TITLE Scandal XK Hang Glider Roll Handling.

CLASSIFICATION Advisory.

APPLICABILITY Serial numbers up to 7436

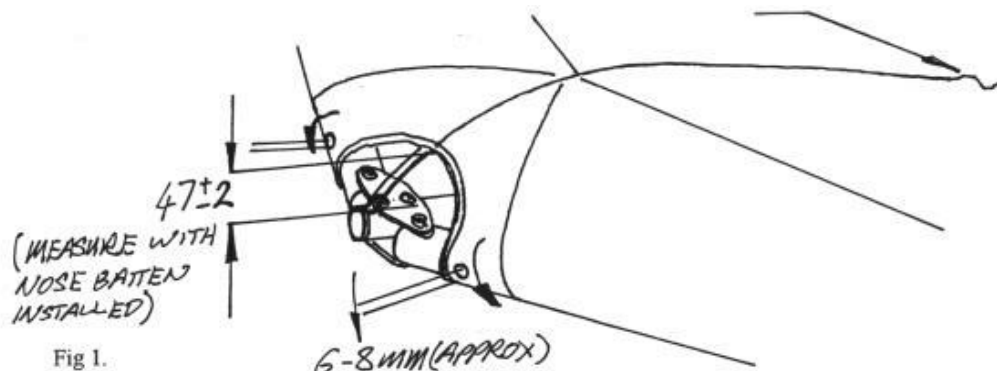
1) Rig the wing complete for flight. Remove the nose attachment sail screws. Remove the nose batten. Rotate the sail downwards until the gap between the top noseplate and the inside edge of the nose aperture is $47\text{mm} \pm 2\text{mm}$ as defined in fig 1. A dimension over 50mm is known to restrict roll response. Re-drill the nose attachment screws using a 3.3mm drill. This will probably be sufficient distance from the original hole to enable a second hole to be drilled; if not, contact the Factory for a replacement leading edge tube nose insert.

The effect of this is to de-tension the wing undersurface in the chordwise direction, enabling the wing to twist more easily in response to weightshift roll inputs. At the same time, any chordwise wrinkle behind the nose batten on the top surface will be seen to reduce in size.

Fig 2.

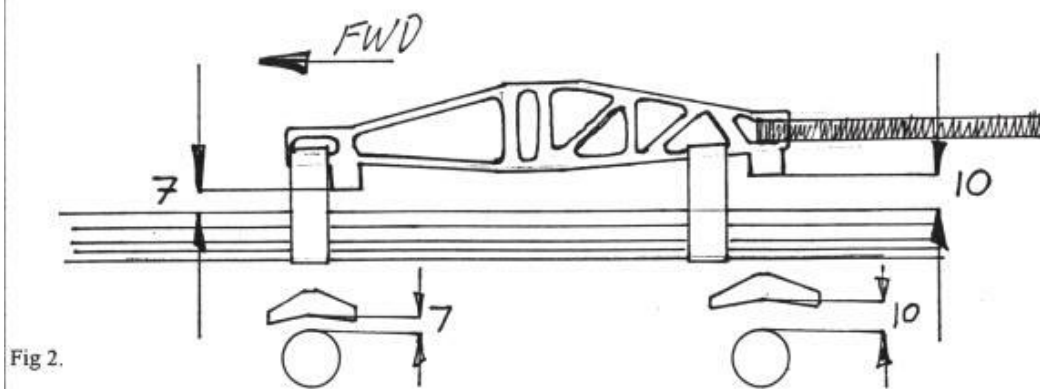
2) Adjust the straps between the keel and the cross-boom leveller until the gaps between the keel top surface and the leveller saddles are $7\text{mm} \pm 1\text{mm}$ (front) and $10\text{mm} \pm 1\text{mm}$ (back) when the straps are tight, as shown in fig 2. Do not increase the front gap more than specified as the mid-span washout rod setting will be adversely affected. If you think the setting has moved, check the mid-span washout rod height as defined in the pilot's handbook. The effect of lengthening the straps is to allow the keel to float sideways as intended, in response to roll inputs, so allowing the sail twist to move assymmetrically across the span.

Fig 3.

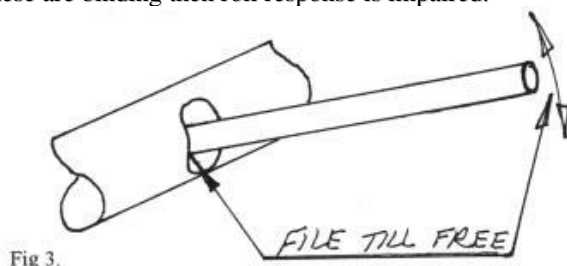
3) Ensure the tip washout rods are completely free to move up and down in their slots. If not, relieve the slot with a fine file (fig 3). Of course, if these are binding then roll response is impaired.
